## BEFORE THE IDAHO PUBLIC UTILITIES COMMISSION

<b>IN THE MATTER OF IDAHO POWER</b> <b>COMPANY'S APPLICATION TO UPDATE</b> <b>SOLAR INTEGRATION RATES AND</b> <b>CHARGES</b>	) ) ) ) )	<b>CASE NO. IPC-E-16-11</b>  <b>ORDER NO. 33563</b>
---	-----------------------	---

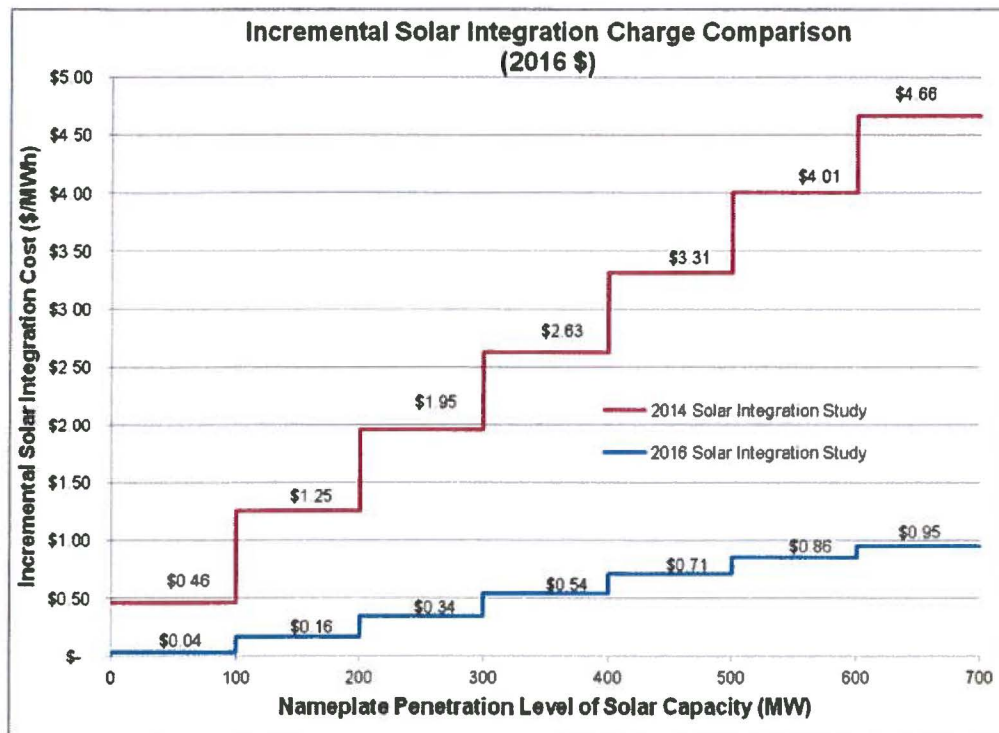
As a result of the 2016 Solar Integration Study, Idaho Power's Application proposed updated incremental integration costs at each 100 MW of solar generation penetration, extending out to 1,600 MW. Application at 5. The costs determined in the 2016 Study are substantially less than those from the 2014 solar integration study, as shown in the following graph.

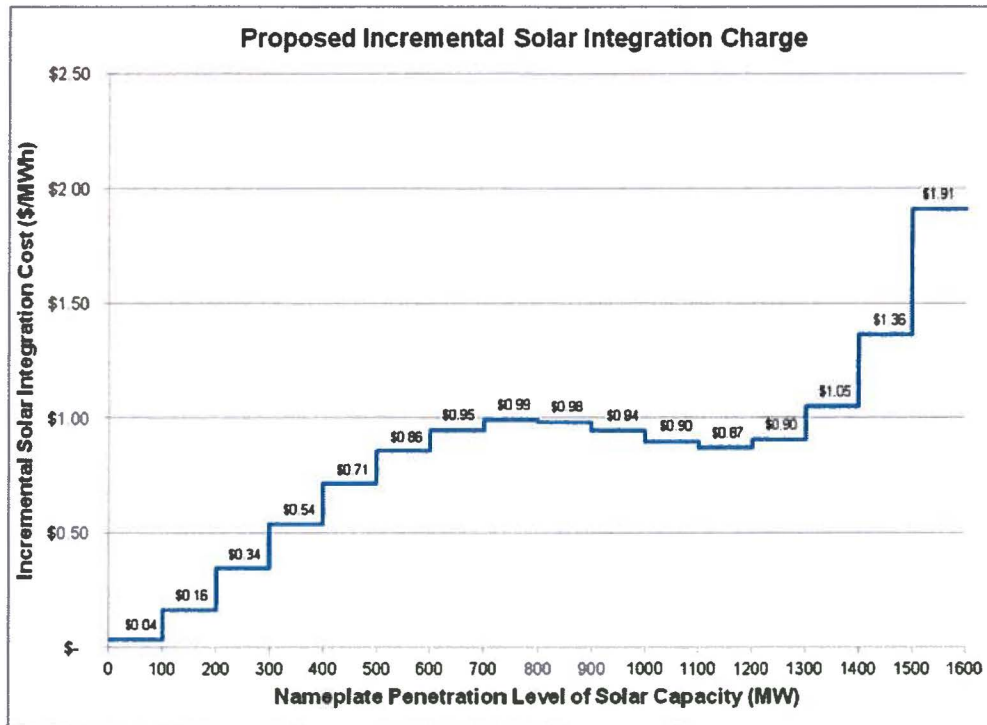
The 100 MW incremental costs of solar integration to 1,600 MW are shown in this chart:
